Access Compliance Report

Public Rights-of-Way

(Curb Ramps)

Intersection ID: 3097	Main Street: PLACER_MAPLE_LN	Cross Street: ALLEN_A_BROWN_RD	Location: NE
ADA ID: E72237007668	Ramp Type: BlendTrans1	Initial Pass/Fail: Fail	Overall Compliance: No
Severity Score: 10			
Codes/Mitigation Info/Possible Solution		Field Measurements/Component Compliance

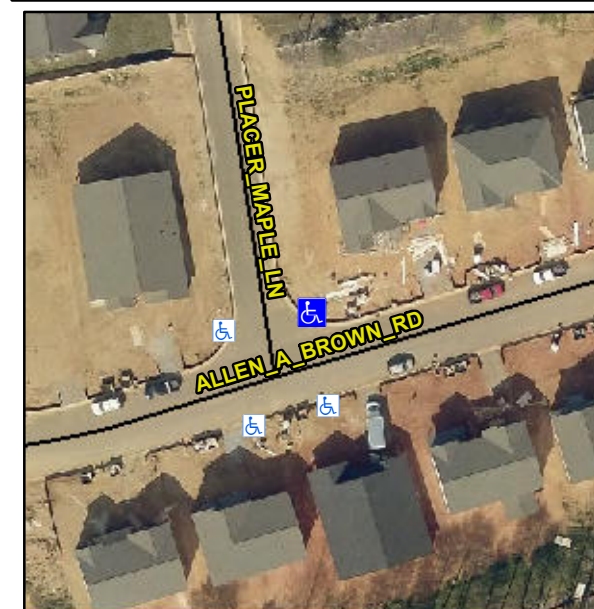
Not Found, R304.5.1, R304.5.3

Compliance	Description	Data	Compliance	Description	Data
N/A	Ramp Length (in)	47.0	Yes	BlendTrans Slope (%)	4.9
No	Ramp Width (in)	47.0	No	BlendTrans XSlope (%)	3.6
N/A	Flare Type LT	N/A	N/A	Flare Type RT	N/A
N/A	Flare Slope LT (%)	N/A	N/A	Flare Slope RT (%)	N/A
N/A	Flare Traversable LT?	N/A	N/A	Flare Traversable RT?	N/A
N/A	Landing Length (in)	N/A	N/A	DWS Provided?	N/A
N/A	Landing Width (in)	N/A	N/A	DWS Contrast?	N/A
N/A	Landing Slope (%)	N/A	N/A	DWS Length (in)	N/A
N/A	Landing X Slope (%)	N/A	N/A	DWS Full Width?	N/A
N/A	Landing Curb? (Y/N)	N/A	N/A	DWS Offset (in)	N/A
N/A	Shared Landing?	N/A			
N/A	Gutter Ponding?	N/A	N/A	Gutter Slope (%)	N/A
N/A	Gutter Lip Ht (in)	N/A	N/A	Gutter X Slope (%)	N/A
N/A	Painted X Walk1?	No	N/A	Painted X Walk2?	No
	X Walk 1 Direction	To W		X Walk 2 Direction	To S
	X Walk 1 Width (in)	N/A		X Walk 2 Width (in)	N/A
	X Walk 1 Slope (%)	5.4		X Walk 2 Slope (%)	0.1
	X Walk 1 X Slope (%)	0.6		X Walk 2 X Slope (%)	4.4

N/A	Ramp inside XWalk1?	N/A	N/A	Ramp inside XWalk2?	N/A
	Road Slope (%)	2.7		Clear Space?	N/A
	Road X Slope (%)	3.6	N/A	Clear Space to XWalk (in)	N/A
N/A	Any Obstructions?	N/A	N/A	Storm Grate/Utility Hazard?	N/A
	Obstruction Type			Storm Grate/Utility Type	
		N/A			N/A
			Yes	Surface Condition? (G/P)	Good
			No	Curb Slope (%)	12.8

Remove & Replace Curb Ramp With Two New Directional Ramps or Equivalent.
